Appl. No.: 10/707,929
Amdt. Dated: 10/24/2005
Reply to Office action of: 08/10/2005

AMENDMENTSTOTHEDRAWINGS:

REMARKS/ARGUMENTS

Fig. 1

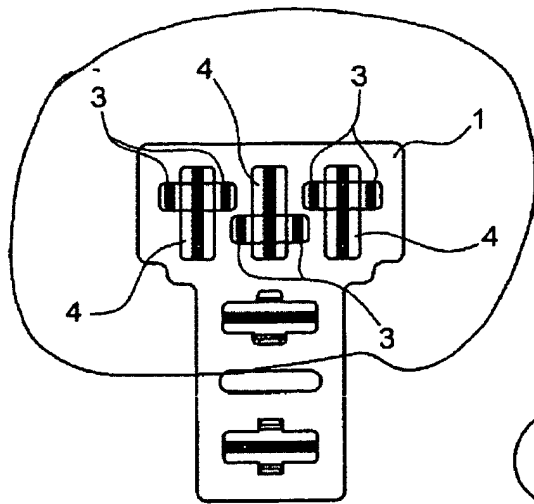
The attached 2 sheet(s) of drawings includes changes to Figures 1 and 2. These sheets, which include Figures 1 – 5, replaces the original sheets including the improper multiple drawing Figures 1 and 2. In Figure 1 previously un-numbered elements have been numbered. In Figure 2 previously unnumbered elements have been numbered and unidentified section lines have been labeled. In addition the multiple drawings on both sheets have been given individual figure numbers and had unnumbered elements properly numbered.

The drawing sheets have been amended to correctly identify each drawing with its own Figure number, correctly number the elements in the figures, provide element numbers for all of the elements including the plugboard itself, and generally to overcome the objections to the drawings pointed out by the Examiner.

Fig. 2

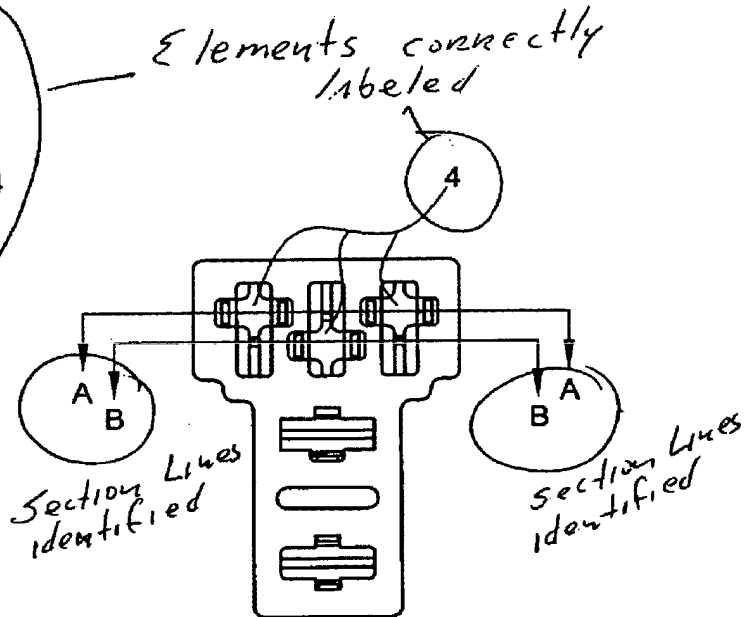
each figure
separately
labeled

Fig. 3

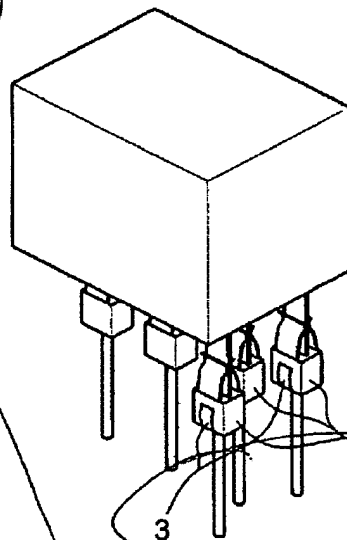
elements
correctly
labeled
